Preliminary Change Request for the Low-Field Corrector Power Supplies of the SNS Ring

NO. 089

March 23, 2001

COLLIDER-ACCELERATOR DEPARTMENT
BROOKHAVEN NATIONAL LABORATORY
UPTON, NEW YORK 11973

Figure 1: Schematic layout showing dipole, quadrupole, sextupole, and corrector magnets of one lattice super-period. The chromatic sextupoles shown in green are not in the baseline.

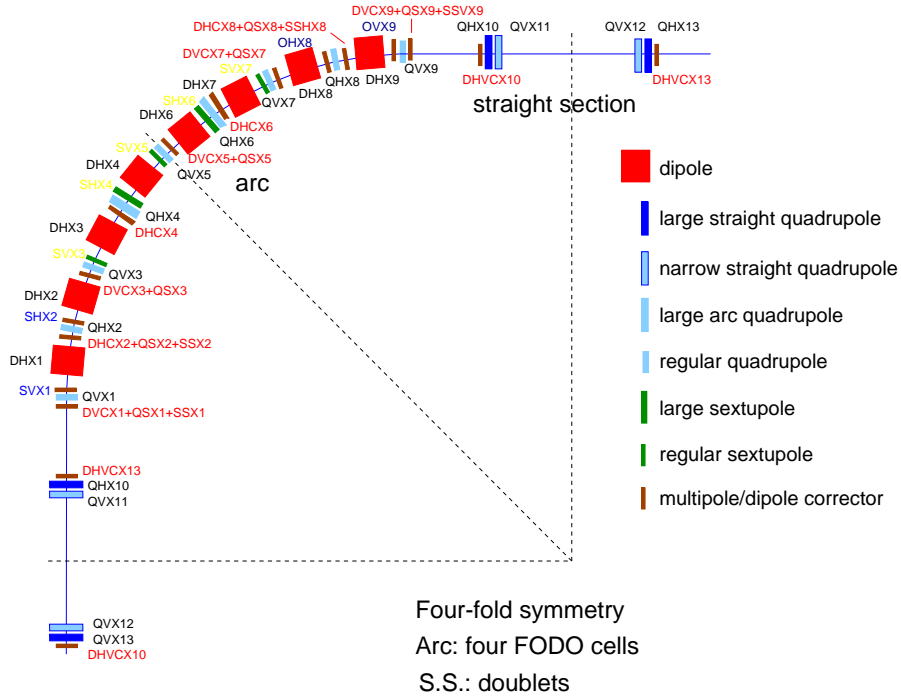
In the initial scheme, the skew sextupole were powered in 2 families. This would have not been enough for correcting any skew sextupole resonance without changing the connection between correctors. Moreover it would necessitate power supplies producing higher voltage and power with an increased cost. Thus, it is required the additional powering of the skew sextupole windings in the 27CDM30 correctors at the beginning of the arc (SSX1 and SSX2) and the connection of the correctors in families of two: the first of the arc with the last and the second of the arc with the third are connected in series (the SSX1 with the SSX9 and the SSX2 with the SSX8, see Fig. 1), forming 8 families.

For the same reason as for the skew sextupole correctors, it was decided to proceed with an individual powering scheme, with 8 power supplies instead of 2 as it was initially proposed. It will allow the possibility of correction of all resonant lines independently of the selected working point [16].

Figure 2: Schematic layout of the correctors’ power supply connection for one super-period of the SNS ring.

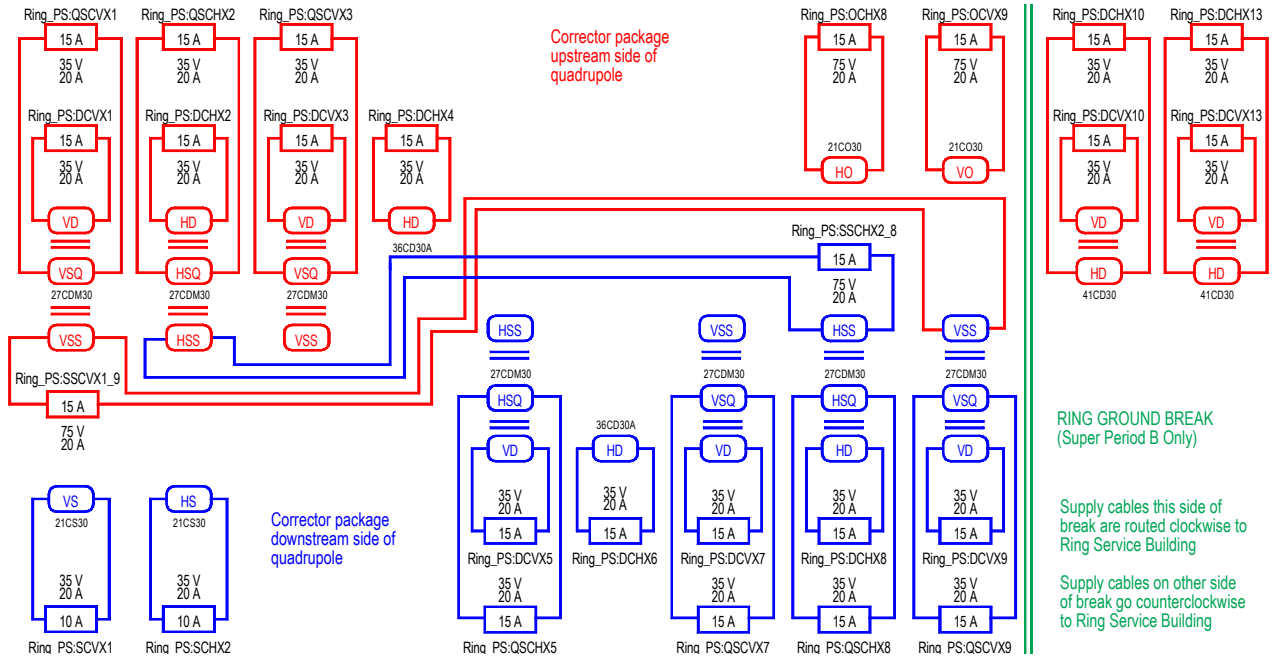
The total number of power supplies needed is 52, one for each arc dipole corrector and 2 for every combined function dipole corrector in the straight sections. The specified field can be given by running the power supplies at 11 A. The baseline proposal for the power supplies procurement remain unchanged and consists of 52 35 Volts power supplies able to deliver currents of 20 A. By adding the 2 power supplies powering the 41CD30 dipole correctors in the ring injection dump, the total number becomes 54.

Figure 3: Schematic layout of the TRIM strings' connection in the SNS ring.

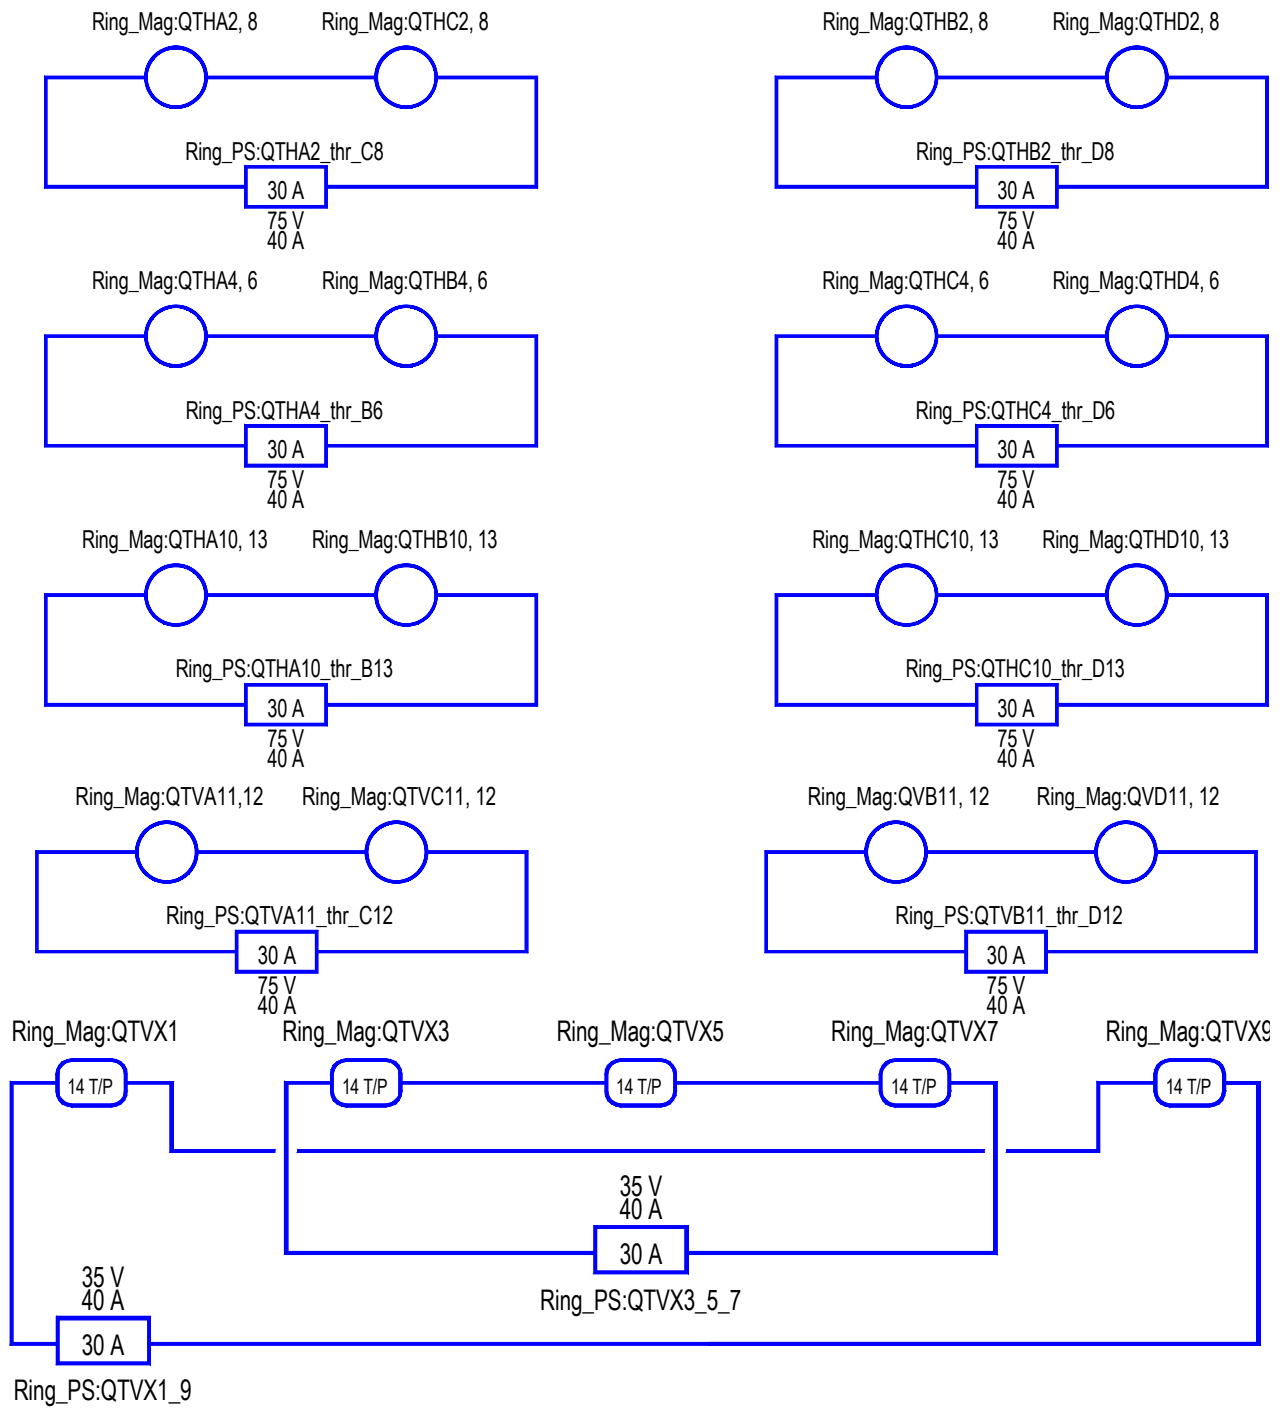
Since the early stage of the project, correction schemes have been proposed for the linear optics distortions and quadrupole resonance compensation, by connecting appropriately in strings the quadrupole windings [8]. The total number of quadrupole string families proposed for the original FODO lattice was seven. With the evolution to the 228m hybrid lattice and later to the 248m 1.3 GeV compatible ring, it became apparent that the number of families will be not enough for correcting all optics distortion. An individual powering scheme was proposed to give flexibility in the correction schemes, to assist the orbit correction in the early commissioning stage and to allow the beam-based alignment of the beam position monitors. A Preliminary Change Request (PCR) [12] was submitted requesting for individual powering

of the quadrupole TRIM windings with 52 power supplies with an additional power supply for regulating the transfer function variation in the arc focusing quads which are powered in series but have different gap diameter due to the aperture increase in the middle of the arc. Due to the de-scoping of the SNS project, the original PCR was not approved. In this note, we propose a more restrictive correction scheme using 16 families of TRIM strings. Studies are under way in order to investigate this latest scheme for different working points and optics perturbations [13].

The total number of power supplies proposed is 16. A preliminary connection scheme is shown in Fig. 3. In order to achieve the required 1% quadrupole gradient in each winding, for all five different types of quadrupoles, the power supplies should be able to give currents of 15 to 30 A. The maximum power supply current and voltage delivered by the power supplies is 40 A and 35 Volts.
